Product Design Assessment

Office Pod Assessment M-Pod & D-Pod

Inapod Pty Ltd

Figure 1: Plan View and Front View of M-Pod

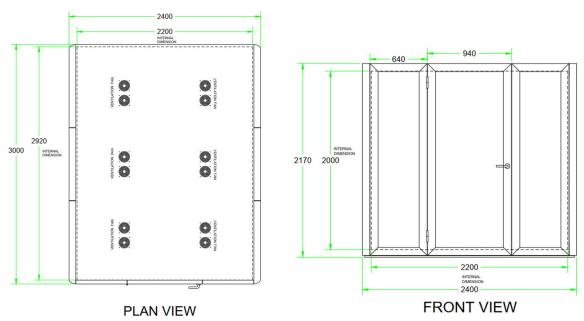
No.	'Deemed-to-Satisfy' Requirements	M-Pod	D-Pod
Paths o	of Travel		
1.	Paths of travel must not contain any steps. AS 1428.1 Clause 6.1	Ramp and auto door operator added to the design. Whilst this does not comply with the deemed to satisfy requirements, we believe this meets the BCA performance requirements DP1	Not applicable as pod is too small for wheelchair access, however access provisions for people with vision impairment comply.

2.	Paths of travel must be minimum 2000mm high (except that they can be 1980mm through doors) AS 1428.1 Clause 6.2	Complies. Internal height shown as 2000mm which will only just comply (will not comply if any fixtures hang below this).	Not applicable as pod is too small for wheelchair access, however access provisions for people with vision impairment comply.

3.	Paths of travel (except at doors) must be minimum 1000mm wide with no impeding fixtures and fittings or door handles less than 900 mm AFFL. AS 1428.1 Clause 6.3	Complies. Without furniture (including table) only.	Not applicable as pod is too small for wheelchair access, however access provisions for people with vision impairment comply.

4.	A circulation space for a 180° turn of minimum 2070 mm in the direction of travel and 1540 mm wide must be provided where at the end of any accessway. AS 1428.1 Clause 6.5.3	Complies. Without furniture only.	Not applicable as pod is too small for wheelchair access, however access provisions for people with vision impairment comply.

6.	Sharp transitions must be provided between the planes of landings and ramps. AS 1428.1 Clause 10.1(a)	Complies.	Not applicable as pod is too small for wheelchair access, however access

Figure 2: Plan View and Front View of D-Pod

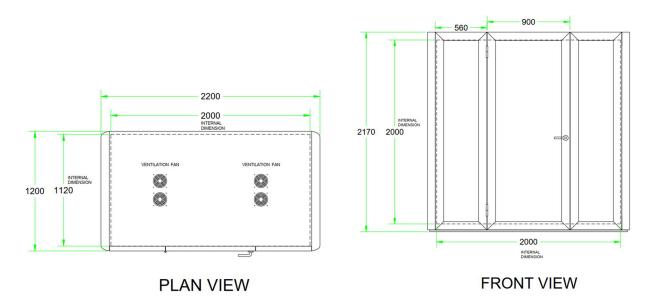
11.	Doors must be provided with circulation spaces on each side with a max. gradient and crossfall of 1:40. Size of circulation spaces will depend on the direction of approach of users and the way a door swings (as per AS 1428.1 Figures 31 & 32). AS 1428.1 Clause 13.3	Complies. Internal circulation will comply (with relocatable furniture) for a front approach. External circulation will depend on the way the pod is installed.	Pod is too small for wheelchair access.
